UNITED STATES PATENT AND TRADEMARK OFFICE

| APPLICATION NO. | FILING DATE | FIRST NAMED INVENTOR | ATTORNEY DOCKET NO. | CONFIRMATION NO. |
|---|-------------|----------------------|-----------------------|------------------|
| 10/565,064 | 07/07/2006 | Peter John Houzego | PC32749A | 6152 |

| Office Action Summary | Application No. 10/565,064 | Applicant(s) HOUZEGO, PETER JOHN | |

DETAILED ACTION

FIG. 12 reduced cross-sectional area

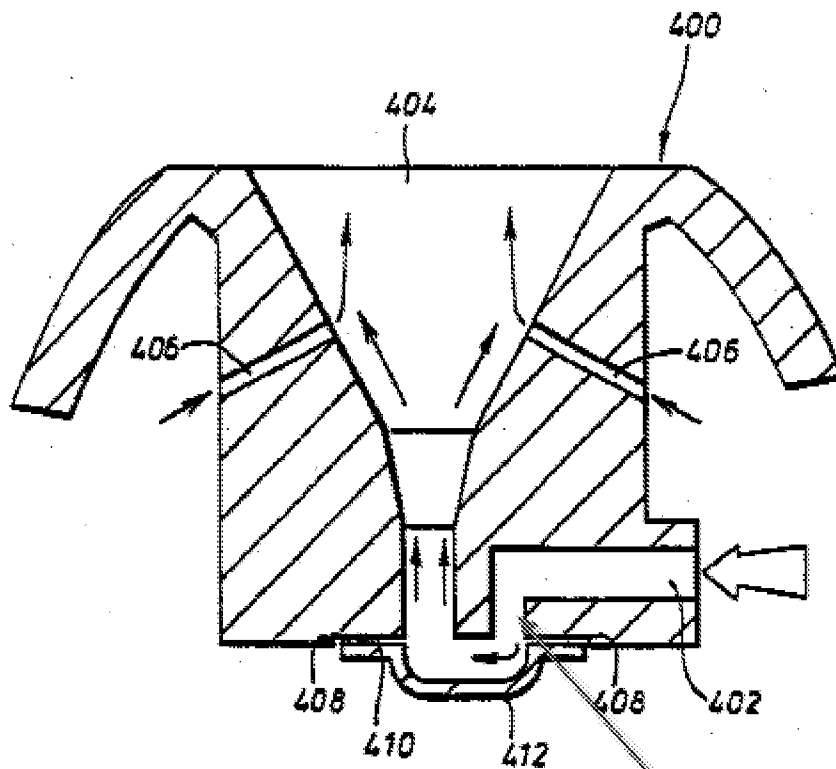
As to claim 9, Cox discloses a device (Fig. 12) for dispensing a dose of powder from a pocket of a carrier including: a support 408/410; and a mouthpiece 400; the

device further including: walls defining first 402 and second 406 flow paths communicating with the mouthpiece 400, the first flow path 402 communicating with the pocket 412 of the supported carrier and the second flow path 406 bypassing the pocket 412; wherein the walls defining the first flow path 406 include, upstream of the pocket 412, a relatively reduced cross-sectional area (see illustrated Fig. 12 below, col. 7, ln. 31-58).

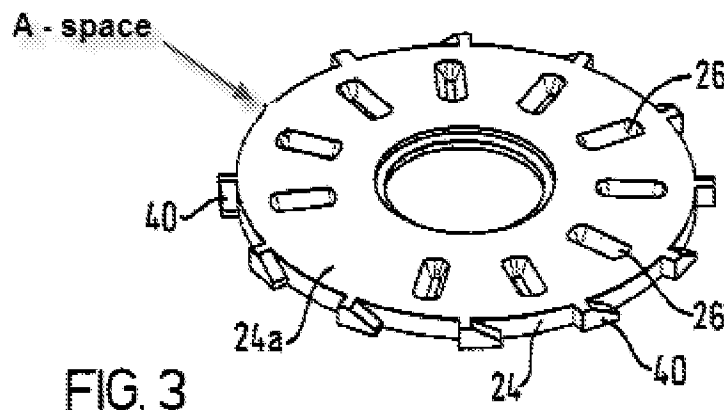
As to claim 36, the modified device of Pike discloses the claimed invention including that the arrays of gear teeth 40 are incomplete circular arrays leaving respective spaces (see illustrated Fig. 3 below).
